70205A-01A

S E R V I C E N O T E

HP 70205A Graphics Display

ROM Replacement Kit

Figure 1

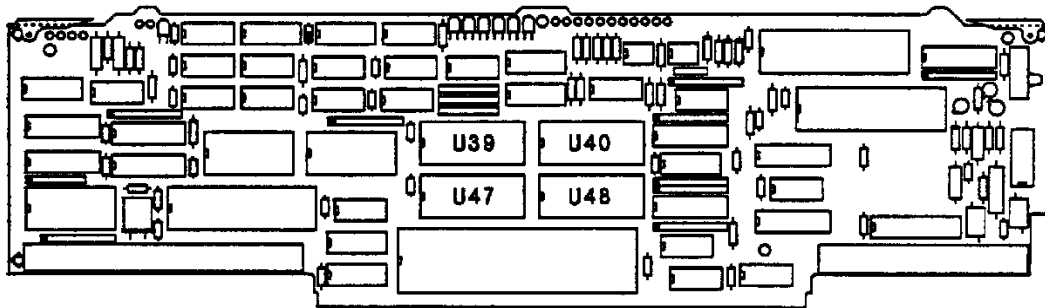
8. Locate (do not remove) the ROMs on the microprocessor board (U39, U40, U47, U48), and note their notch orientation. The original ROMs currently in the board should have HP Part Numbers 70205-80004 through 70205-80007. The new ROMs have HP Part Numbers 70205-80037 through 70205-80040 respectively. See Figure 1.

9. Remove original ROM U39, 70205-80004 and replace it with new ROM 70205-80037. Place the original ROM in the anti-static foam block, then repeat the sequence for U40, U47, and U48 so that the following list is satisfied.

U39 70205-80037
U40 70205-80038
U47 70205-80039
U48 70205-80040
